ADDENDUM NO. 1

PROJECT NAME: Atlas Ranch Elementary

CLIENT NAME: Jarrell ISD

ADDENDUM DATE: November 3, 2026

1 FOUNDATION PLAN - AREA 1
S2.01 1/8" = 1'-0"

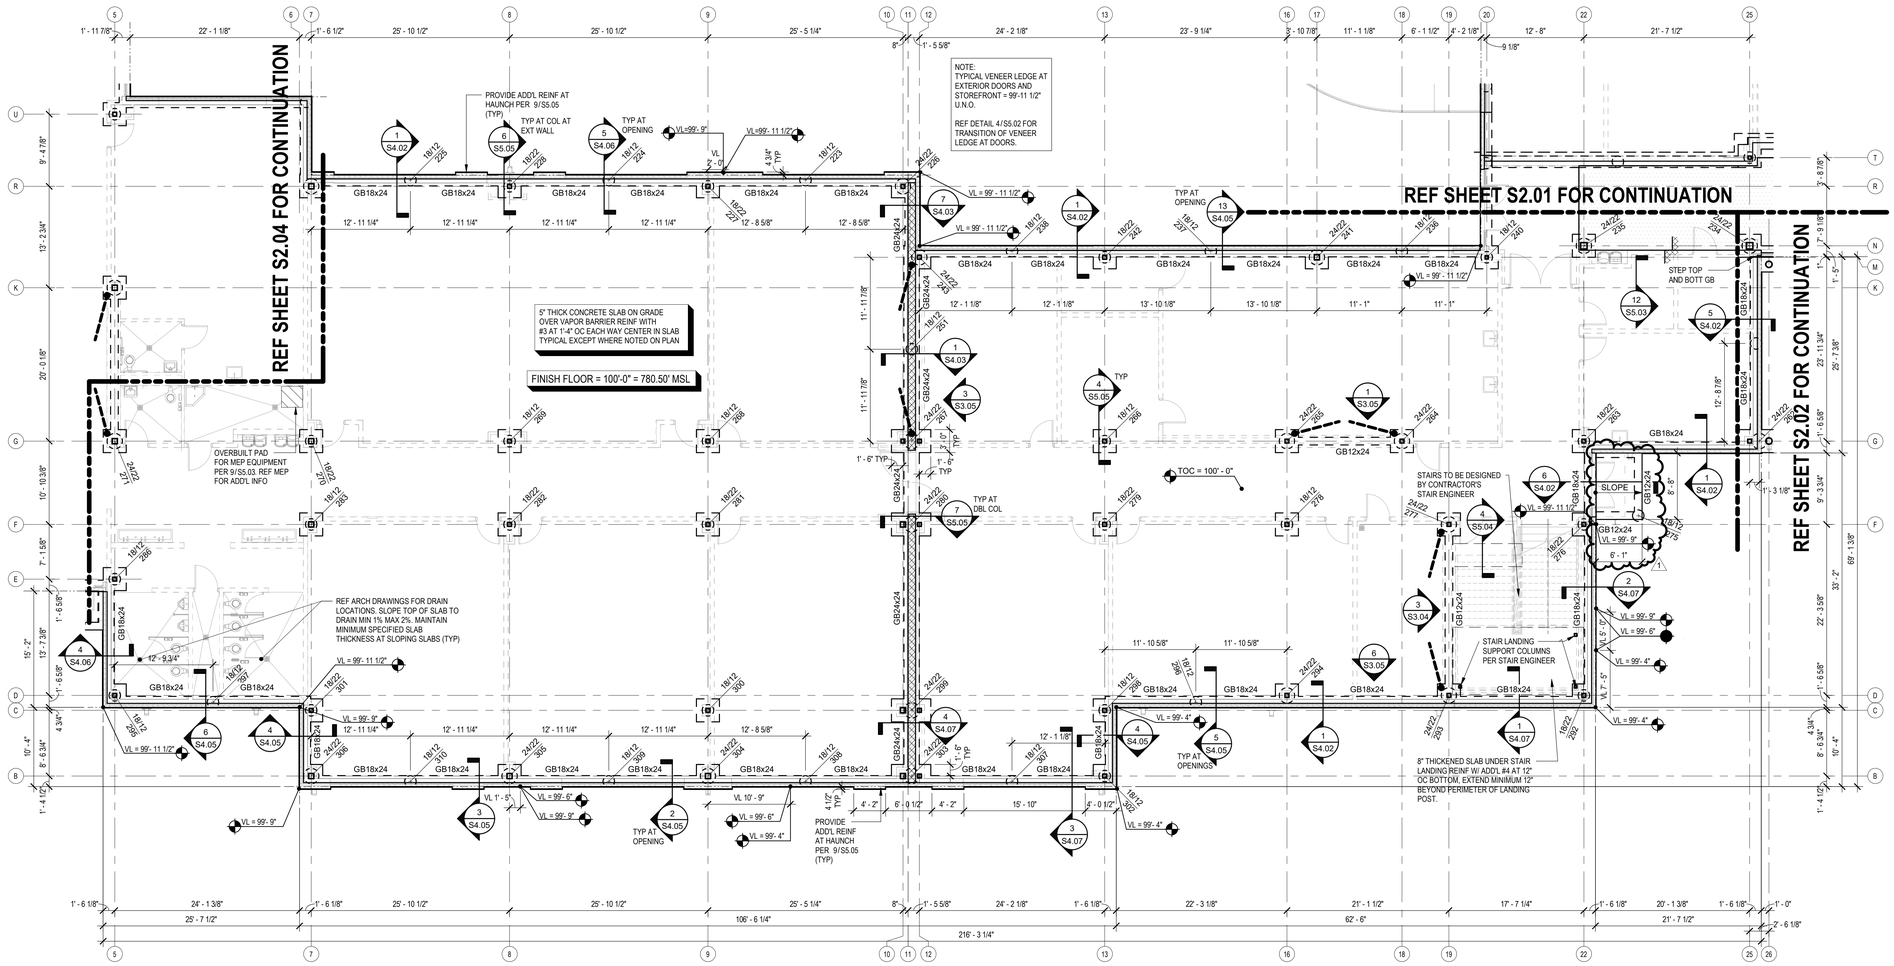
AD No 1, Struct Item 2: To the Drawings, Sheet S2.01, "FOUNDATION PLAN – AREA 1,"
Replace sheet S2.01 in its entirety with sheet S2.01 attached as part of this Addendum. The front entry stoop has been recessed for pavers. As a result, new sections have been called out at multiple stoops for clarity, the elevation of one grade beam has been modified, and the length of the front entry stoop has been updated. The material of a bench has been updated to CFMF in lieu of concrete over polystyrene. All topping slab tags have been updated.

01 FLOOR PLAN - AREA 2 - LEVEL 1 - PLUMBING - SUPPLY

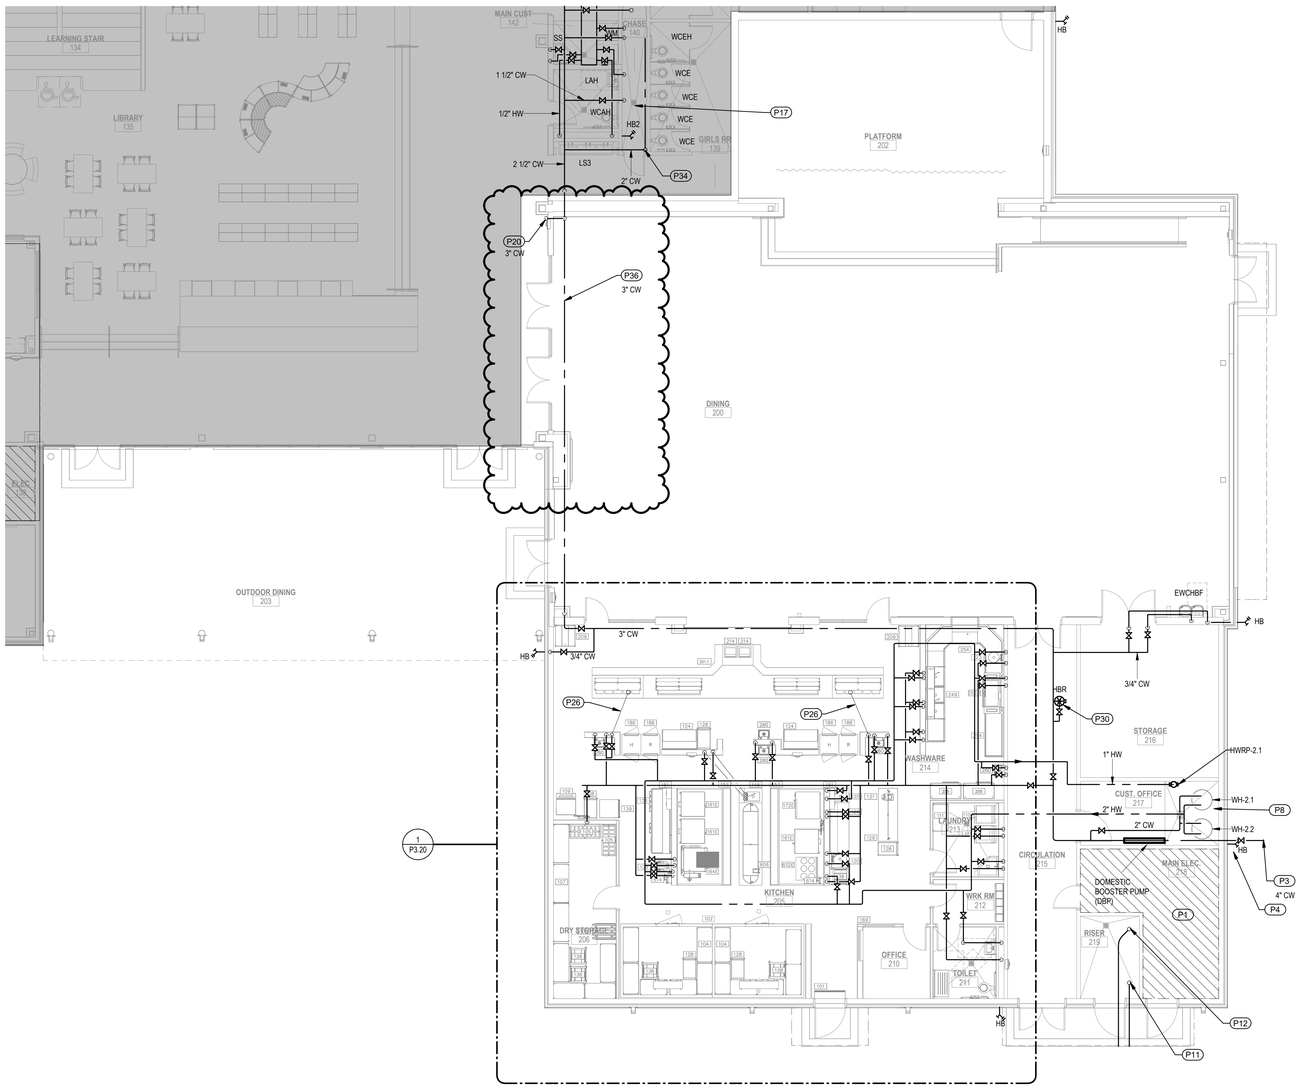
AD No 1, PLBG Item 4: To the Drawings, Sheet P3.02 "FLOOR PLAN – AREA 2 – LEVEL 1 – PLUMBING – SUPPLY"

01 FLOOR PLAN - AREA 7 - LEVEL 2 - PLUMBING - SUPPLY

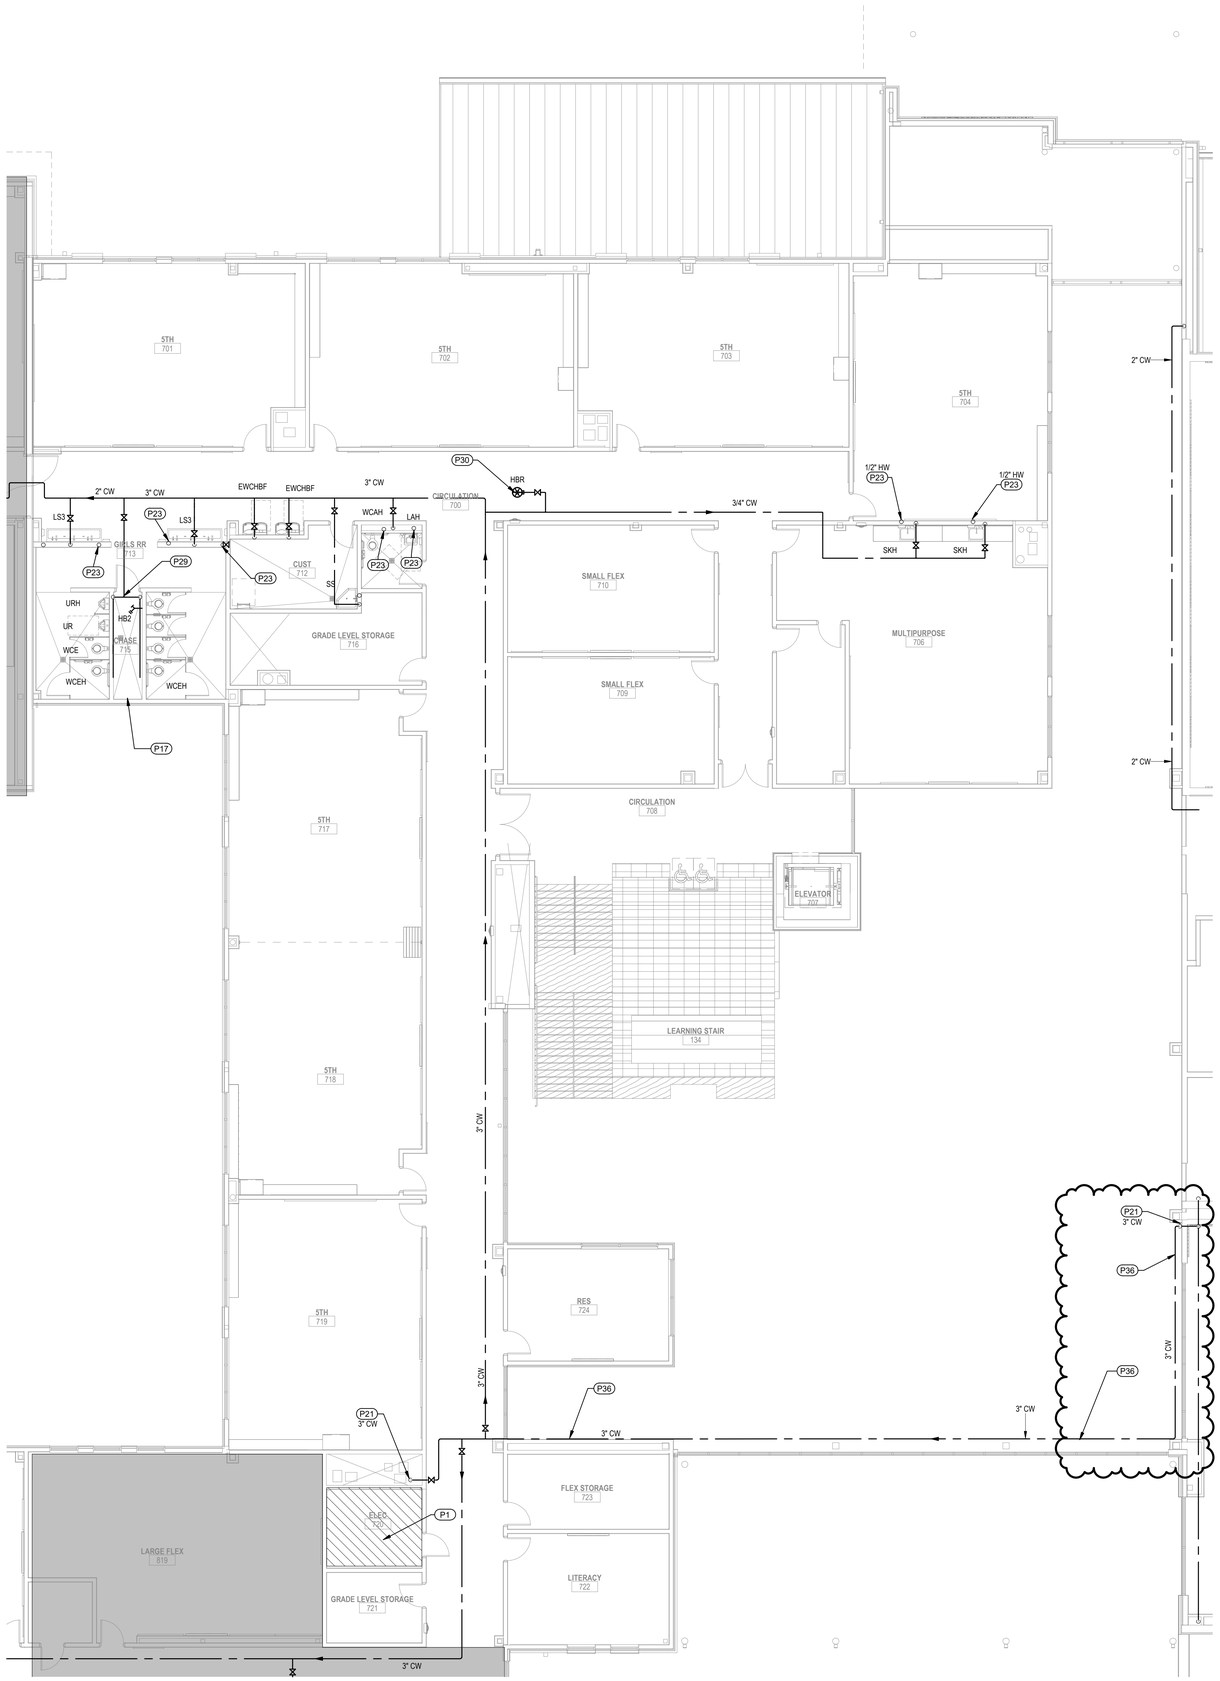
AD No 1, PLBG Item 6: To the Drawings, Sheet P3.07 "FLOOR PLAN – AREA 7 – LEVEL 2 – PLUMBING – SUPPLY"

01 FLOOR PLAN - AREA 5 - LEVEL 1 - MECHANICAL

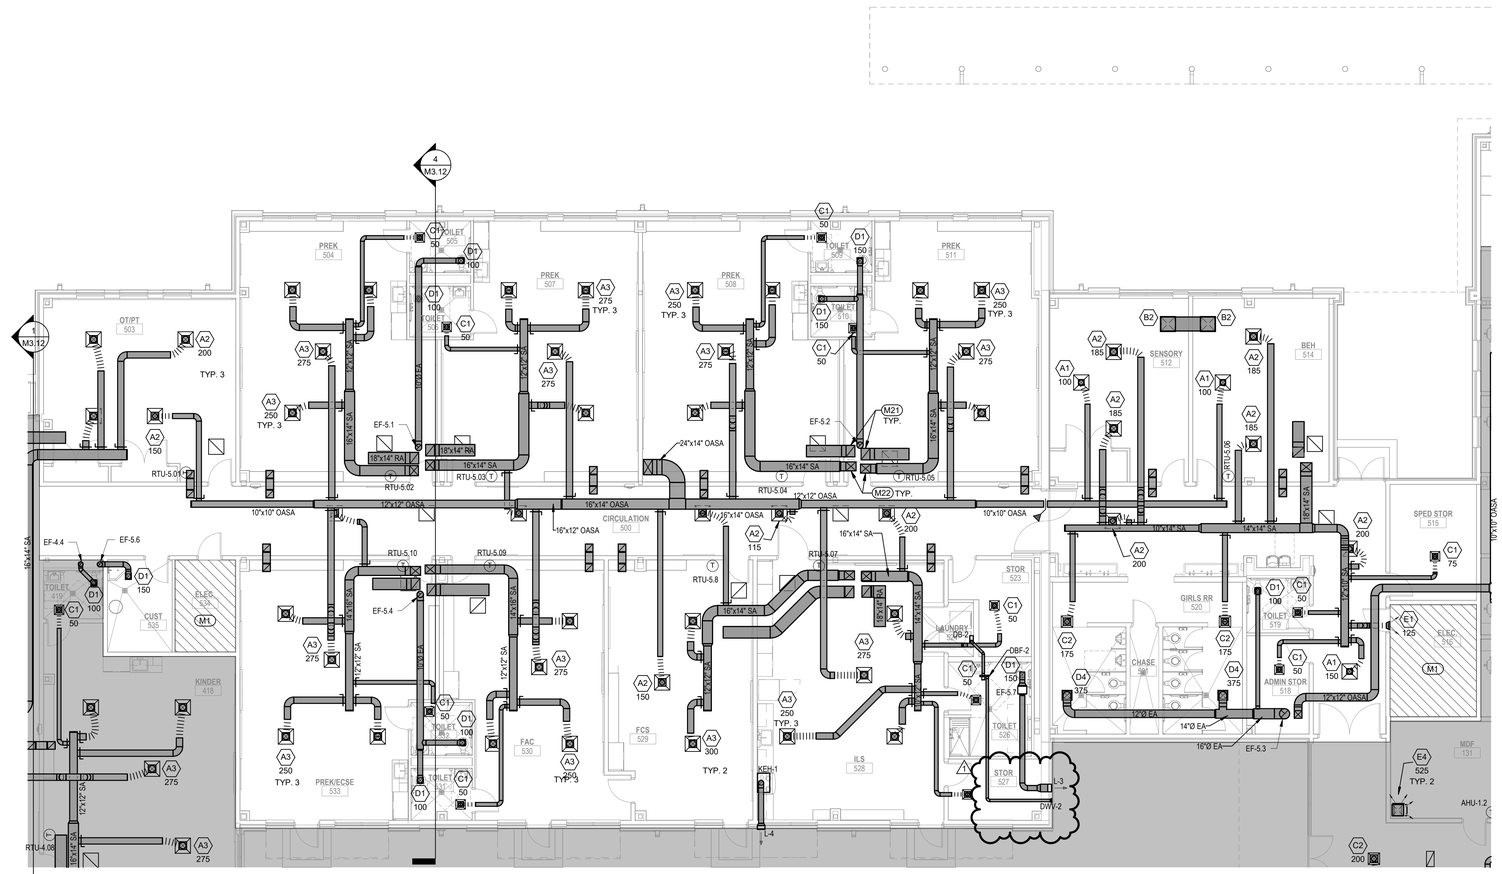
AD No 1, MECH Item 1: To the Drawings, Sheet M2.05 – FLOOR PLAN – AREA 5 – LEVEL 1 - MECHANICAL

01 FLOOR PLAN - AREA 7 - LEVEL 2 - MECHANICAL

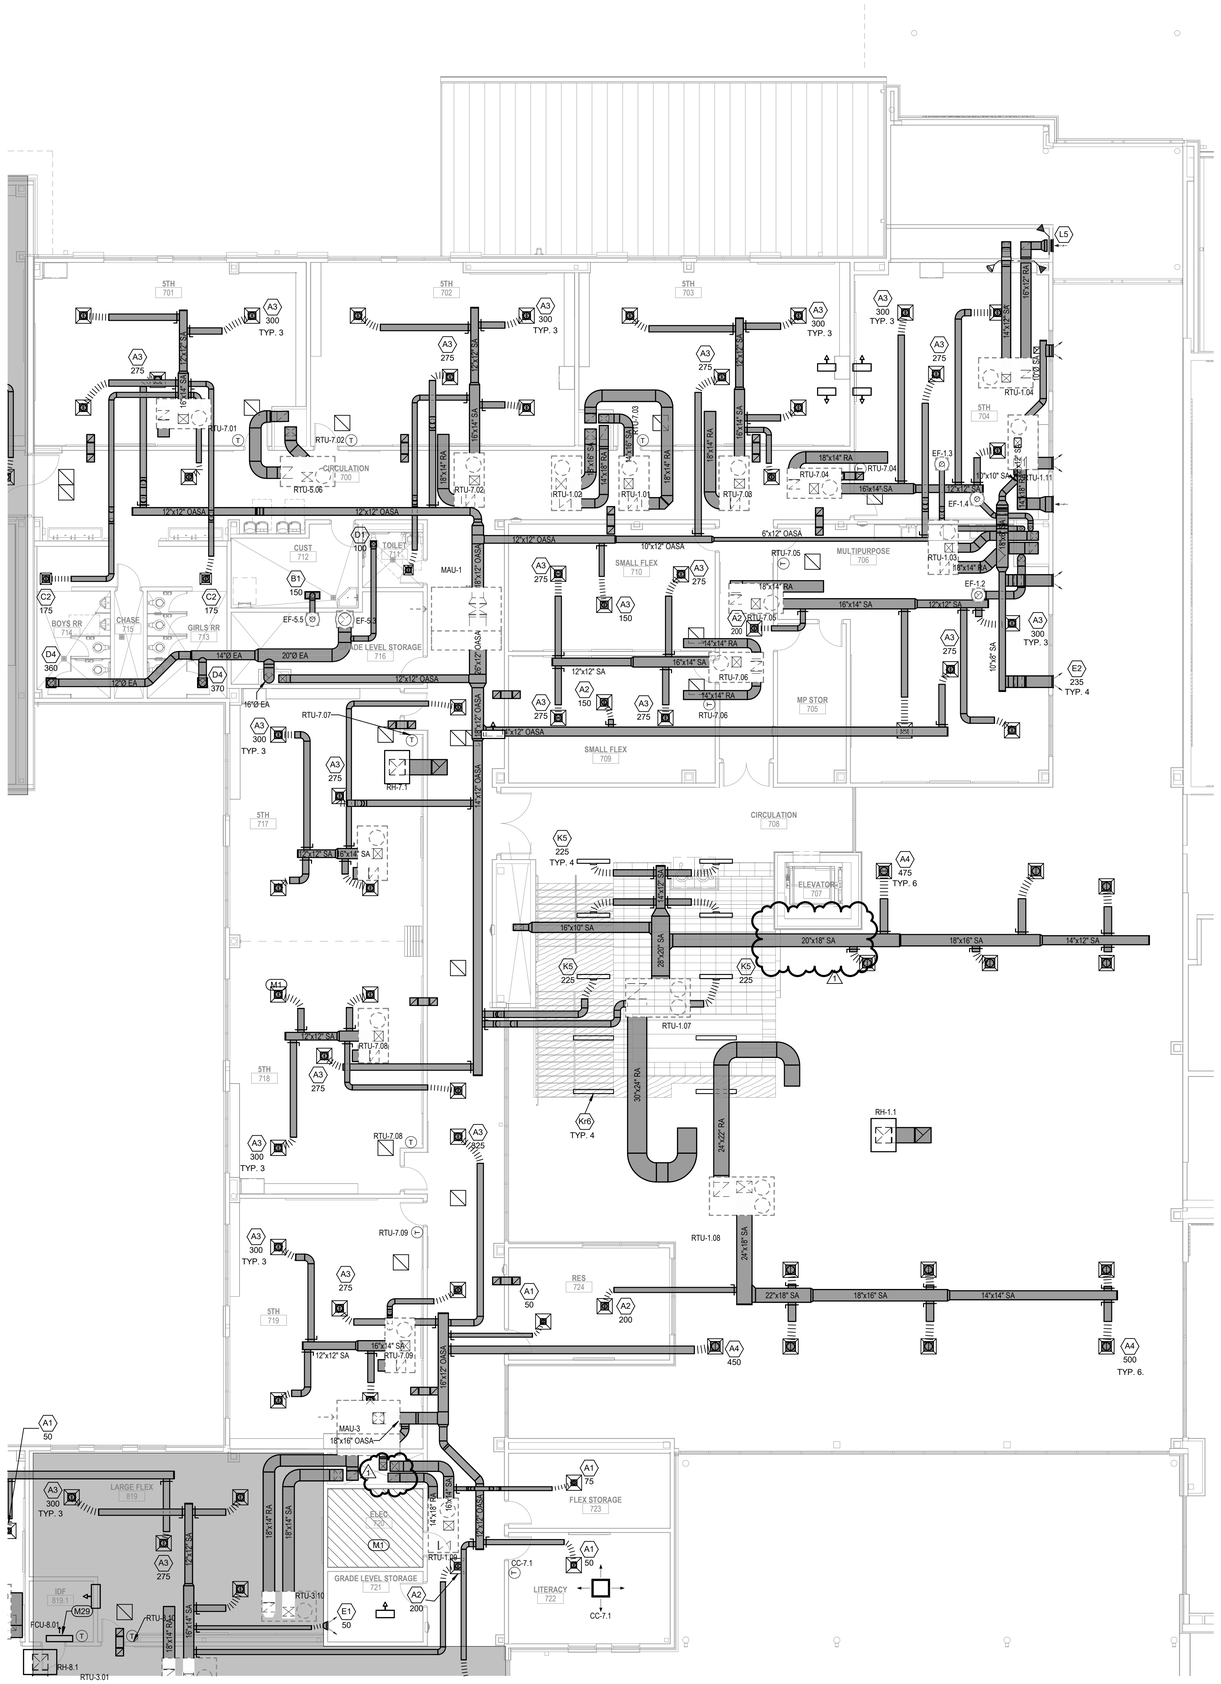
AD No 1, MECH Item 2: To the Drawings, Sheet M2.07 – FLOOR PLAN – AREA 7 – LEVEL 2 - MECHANICAL

01 FLOOR PLAN - AREA 9 - LEVEL 2 - MECHANICAL

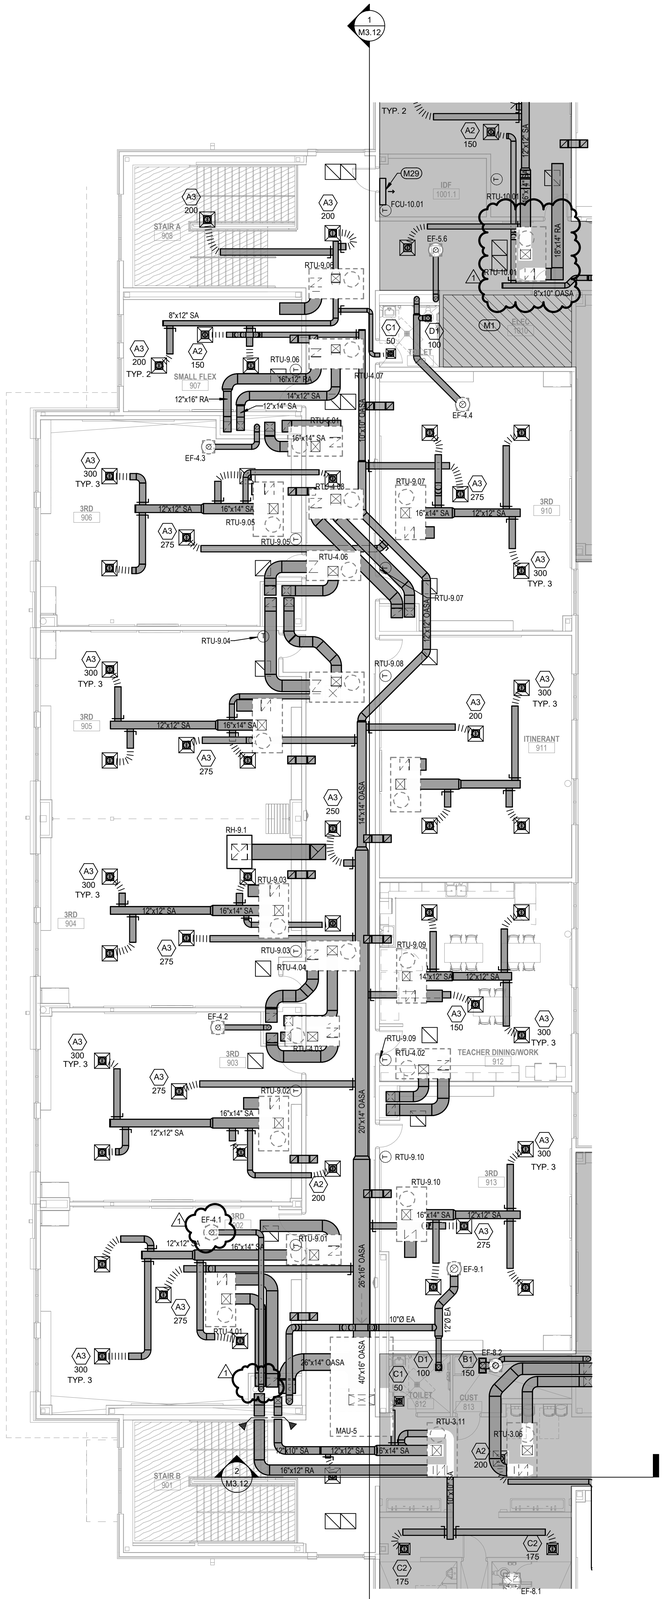
AD No 1, MECH Item 3: To the Drawings, Sheet M2.09 – FLOOR PLAN – AREA 9 – LEVEL 2 - MECHANICAL

01 FIRST FLOOR PLAN - AREA 6 - LIGHTING

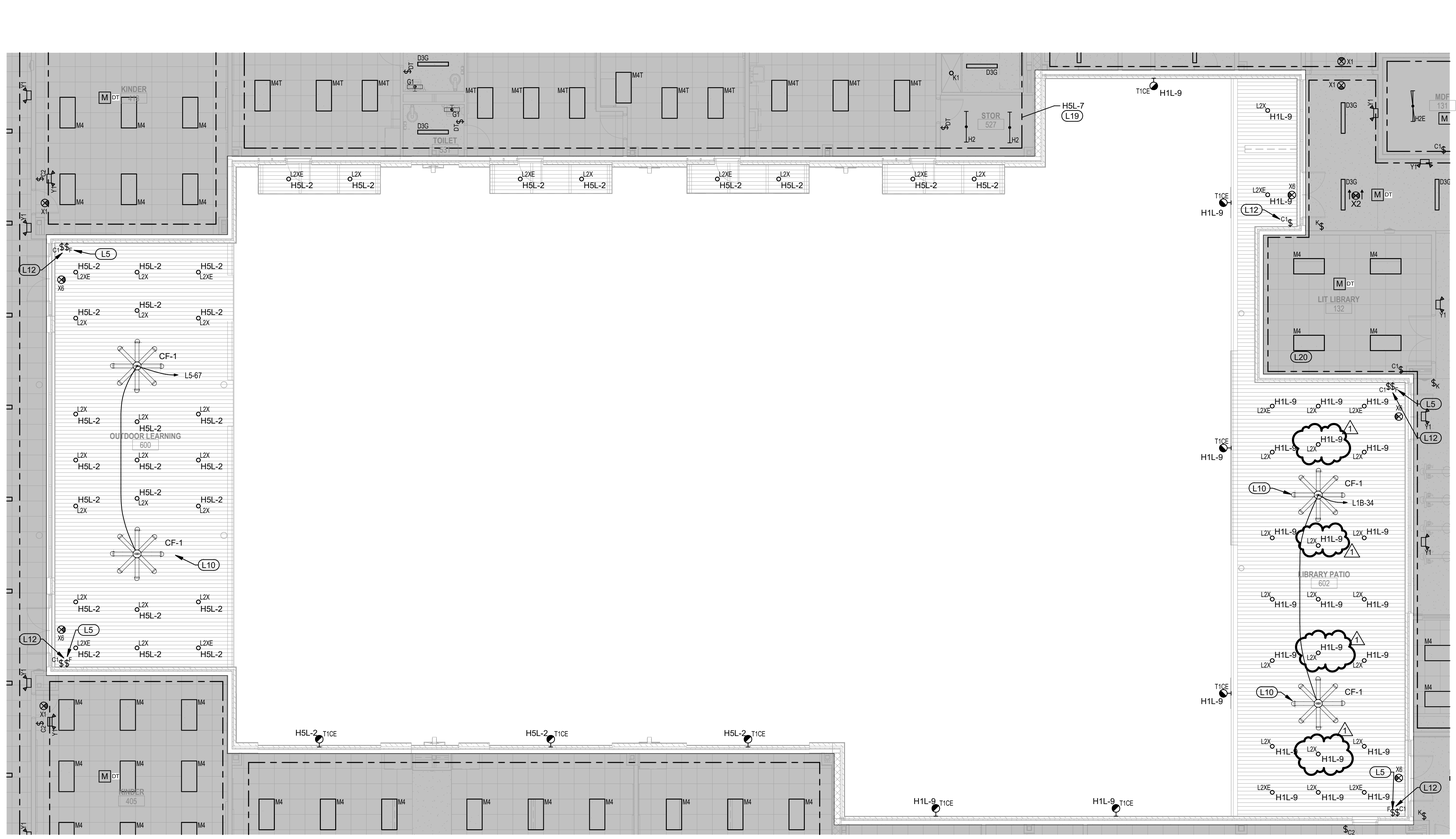
AD No 1, ELEC Item 3: **To the Drawings, Sheet E2.06 - FLOOR PLAN - AREA 6 - LEVEL 1 - LIGHTING**
